U.S. NUCLEAR WASTE TECHNICAL
REVIEW BOARD

REPORT TO
THE U.S. CONGRESS
AND
THE SECRETARY OF ENERGY

January to December 1996

Figure 2. Features of the Exploratory Studies Facility (DOE drawing).

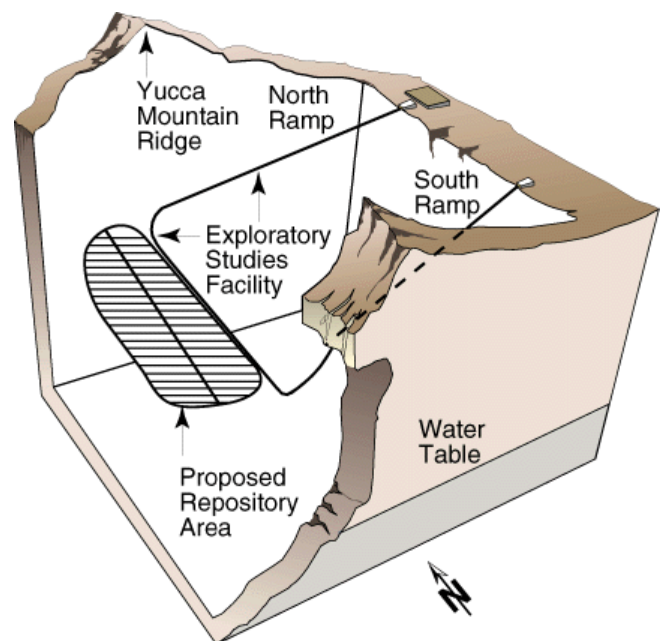
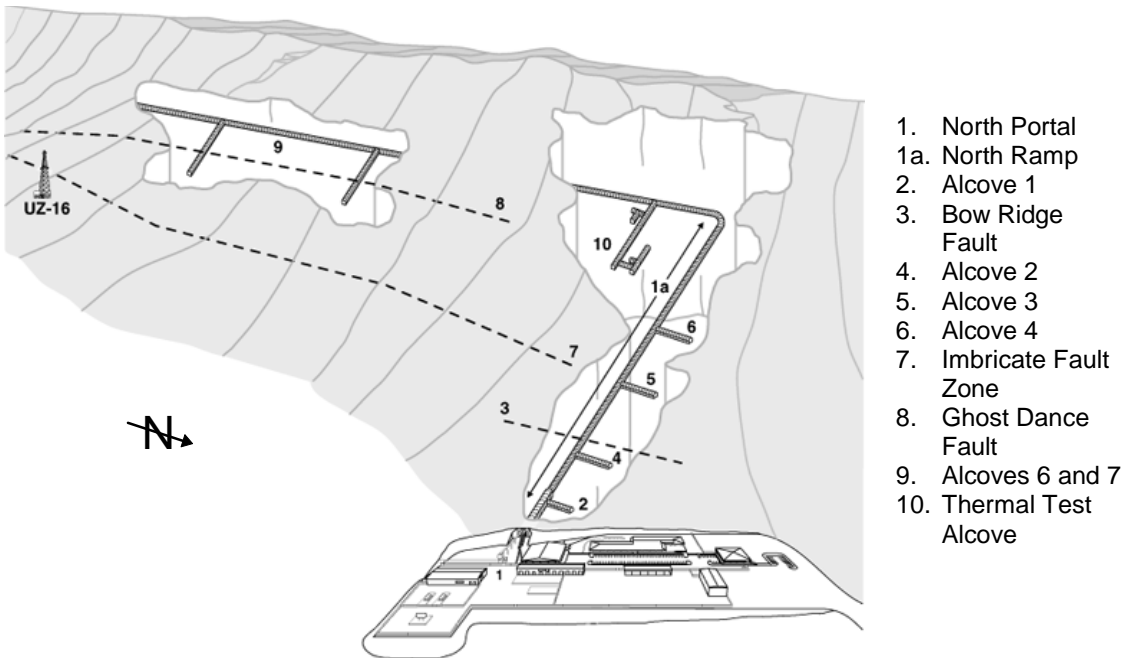
⁷ Figures 1 and 2 suggest that the main ESF tunnel ("main drift") lies directly below the crest of Yucca Mountain. Actually, the main tunnel and much of the proposed repository area lie to the east of the crest, as illustrated in Figure 4 on page 18.

Figure 3. Progress in ESF Excavation

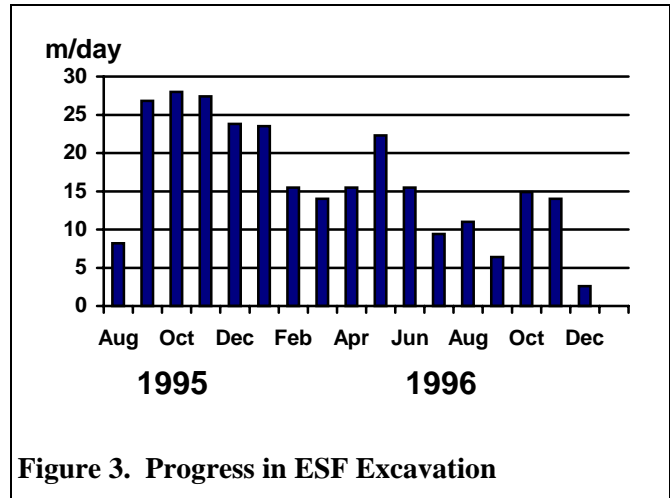
The performance of the TBM varied widely from month to month, as shown in Figure 3. A factor contributing to slow progress may have been the north-south alignment of the main drift, roughly parallel to the major joint set (rock fractures). This alignment may have helped cause localized “fall-outs” of rock as the tunnel was excavated by the TBM. Later, when excavating the south ramp, regions of high fracture density added to rock instability around the TBM, requiring the time-consuming installation of heavy ground support.

Figure 5. Illustration of 21-PWR Spent-Fuel Waste Package

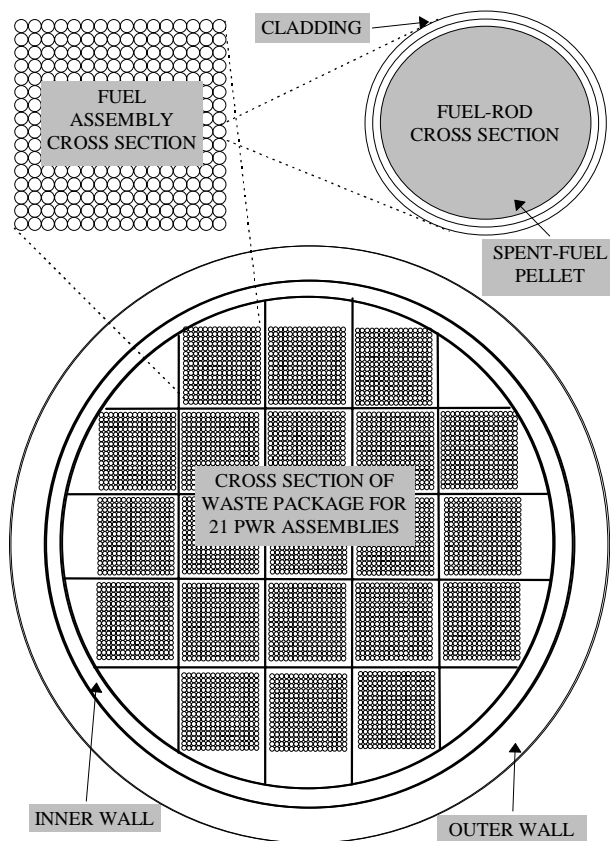
Since the current waste package design was adopted, the amount of water estimated to seep into the drifts has increased significantly. Furthermore, essentially *no* data have been obtained from the area west of the ESF where the waste will be emplaced. If such data were generated, uncertainties in the current estimates of the magnitude and distribution of seepage into the waste emplacement area perhaps could be reduced. At the current level of uncertainty about percolation flux and distribution, prudence dictates giving serious consideration to adding engineered barriers to the waste packages.
